Errata 1 to EPROM Emulator NG, PCB versions 1.6 and below.

Dear users of the EPROM Emulator NG, I recently discovered a potential flaw in the design of the emulator. Refer to the diagram of the emulator posted to GitHub dated (2020-05-05), parts shown here:

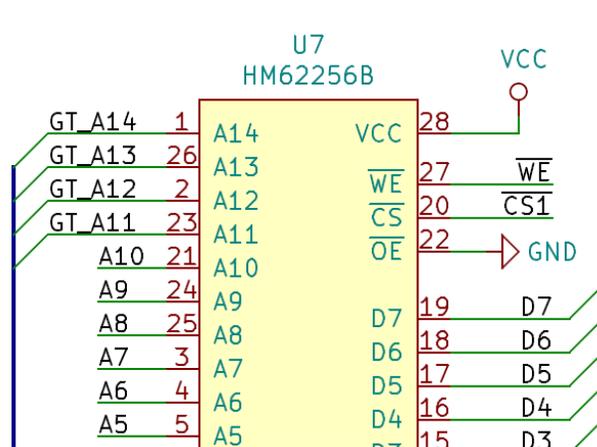
As you can see, the /OE line (pin 22) is connected to ground (GND), permanently enabling the output of the one of the SRAMs at any point of time (the other control line /CS is driven by the state of address line A15). This creates a potential issue, when the emulator is waiting for data from the computer and the shift registers are enabled, driving at the same time the data bus. This situation continues until data from computer or the SPI EEPROM is loaded into SRAM and the “emulation” starts (shift registers get disabled and external buffers - 74HC541 enabled). In my initial design and prototype of the emulator I had those lines correctly connected to the “Reset” signal, this way it guarantees only one of those can be active on the data line at any point, but while I was troubleshooting a completely unrelated issue I disconnected the OE lines from Reset and connected them to GND, I carried over the flawed design to later releases of the PCBs and only just noticed the mistake.

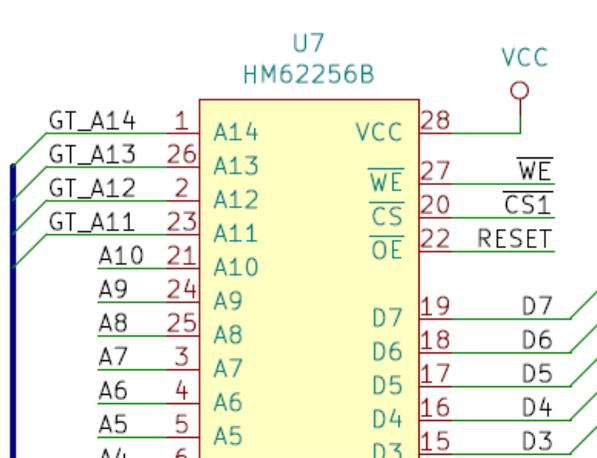
Interestingly this has not caused any functional issue for the many emulators that are currently in use, they are working and serving many of you very well, never the less I will publish updated diagram and new PCB design (1.7), the correct way to connect the SRAM is as follows:

New builds of the emulator should follow the corrected design and the new PCB layout. For current users I recommend doing **ONE** of the following:

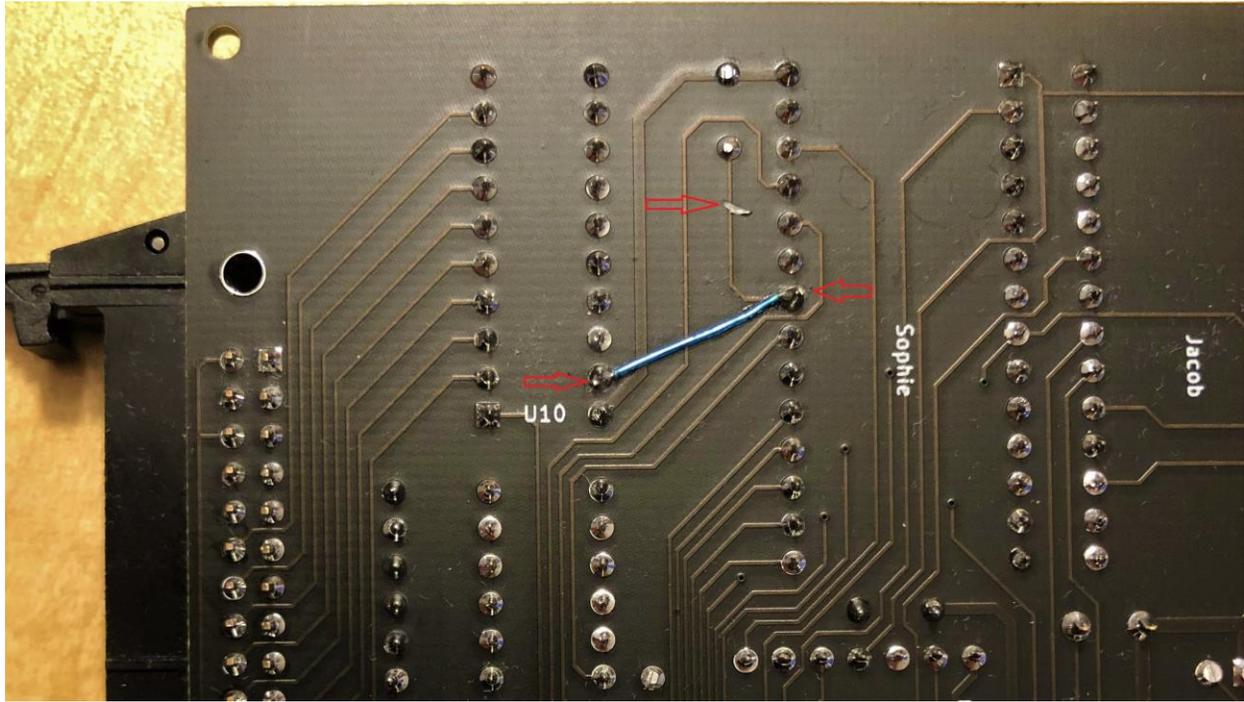
Option A: Hardware modification of the PCB: very simple, cut one track to separate the /CS line from GND, and run a short link of wire to connect the /CS to RESET:

I have tested both options and they work as expected, but “**Option A**” would be **preferred** as it guarantees in hardware that data bus “clash” doesn’t happen.
